REPORT OF: LANDMARKS COMMISSION	<b>PRESENTED:</b> 20 March, 2017
TITLE: 200 S Pinckney St (Block 88 & 105) – Judge Doyle Square – New (Underground) City Parking Facility & New Mixed-Use Development adjacent to a Landmark in Ald. Dist. 4.	<b>REFERRED:</b> <b>REREFERRED:</b>  <b>REPORTED BACK:</b>
CONTACT: Stephen Mar-Pohl, InSite Consulting Architects, LLC	
AUTHOR: Amy Scanlon, Secretary	<b>ADOPTED:</b> <b>POF:</b>
DATED: 21 March, 2017	<b>ID NUMBER:</b> 46063

TITLE: 200 South Pinckney Street (Block 88 & Block 105) – Judge Doyle. 4<sup>th</sup> Ald. Dist. (45612)

Re: Judge Doyle Square Proposal  
Plan Commission comments

1-08

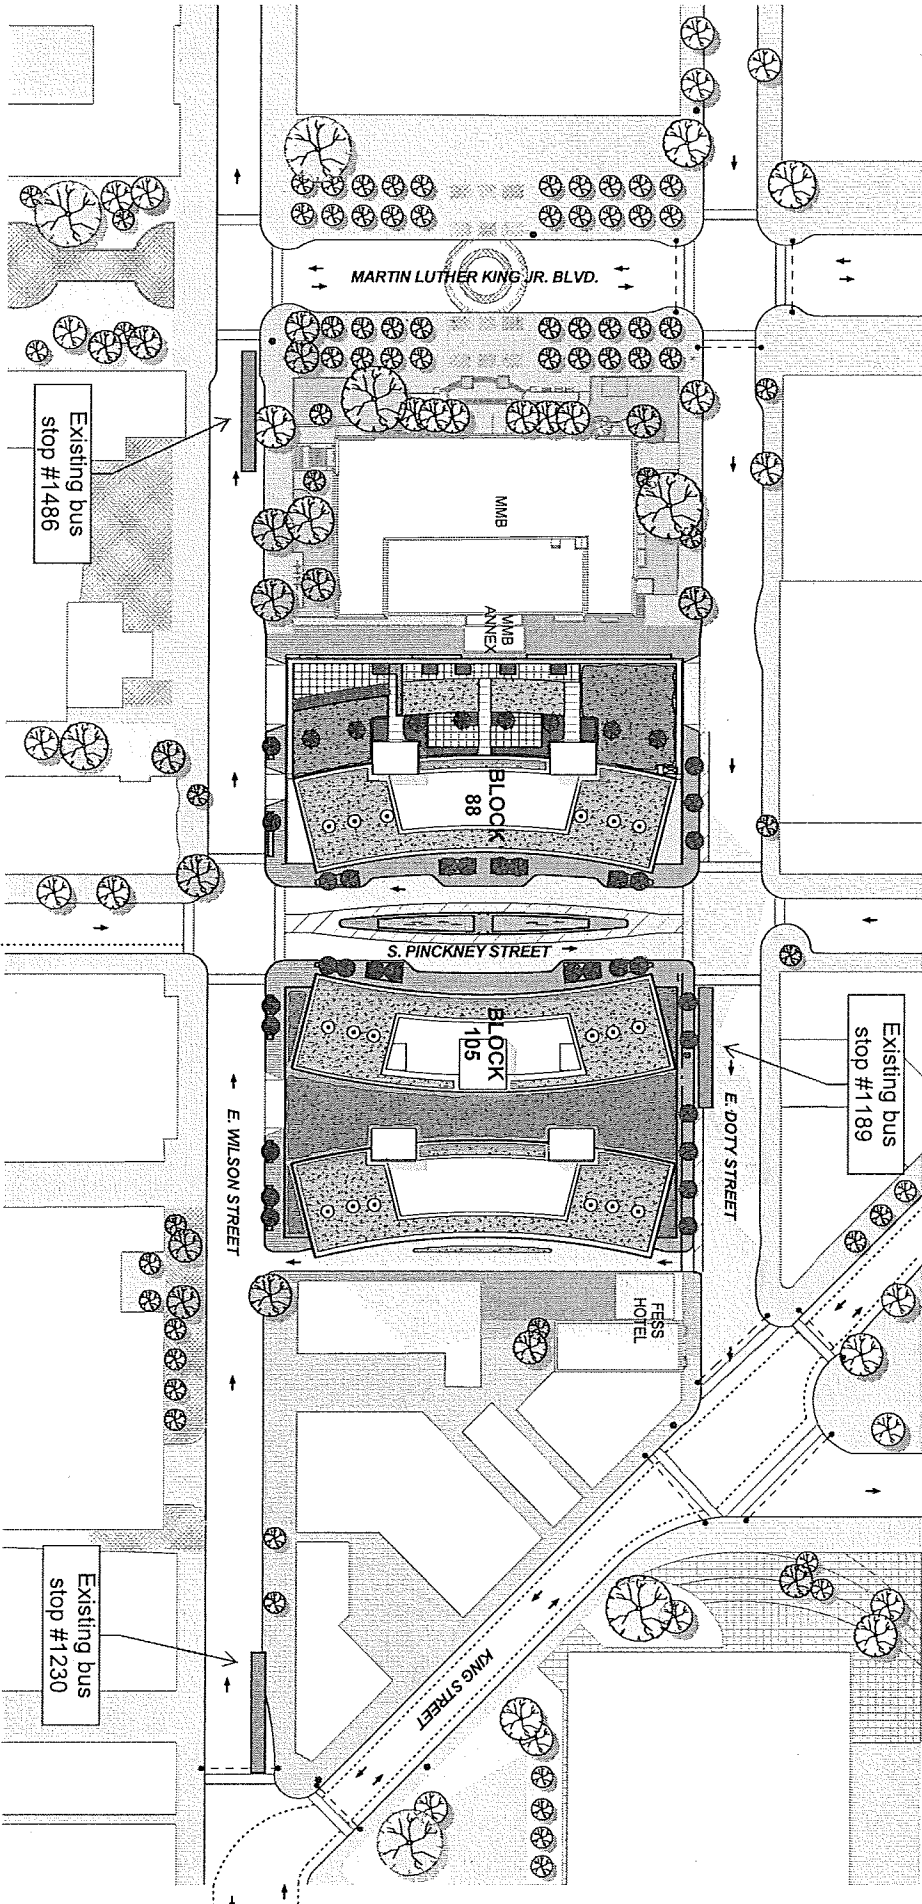
- On 1-08; how big is the crosswalk...how wide is that? Also, how wide is the section separating the ponds in the water feature? How wide are the two ends? Looking at the side on East Wilson, is that a garage entrance?

The locations of street trees on this plan are at odds with locations shown on the Ground Floor Landscape Plan (three pages further into the submittal) and other plan sheets in the submittal. Our understanding is that the proposed street tree locations have not been thoroughly reviewed by staff in Forestry, Traffic or the Fire Department and are subject to change.

- 12 feet; radius of 5-6 feet on each end. Lot 105 is two loading dock entries with one garage entrance. On Block 88 is the public garage entrance.

Figure 1 – 3 lane gating to 2 lane access at street

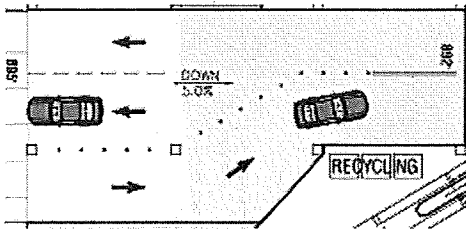
At the Wilson St access the gating facilities could be moved further into the building to allow for narrowing of the sidewalk opening. (Fig. 1) Entry queuing space would still be available and exit queuing space is available on the ramp leading to the gates. A single exit lane also reduces the conflicts inherent with two exits lanes when two vehicles try to exit simultaneously.

The Wilson St. access includes two 4.5' wide aisles for motorcycle entry and exit which extend out to the sidewalk. The Parking Utility has determined that the motorcycle lanes can merge with the vehicle lanes inside the building reducing the opening width by 9'. They have also suggested that the opening could be reduced an additional 6' and still provide three 10' lanes at the sidewalk. While this is clearly an improvement a 30' wide opening fails to meet the specifics and intent of the zoning code and Downtown Plan. Moving the gating location inward to provide only a two lane access point at the sidewalk is both functionally sufficient and superior in creating a desirable urban form.
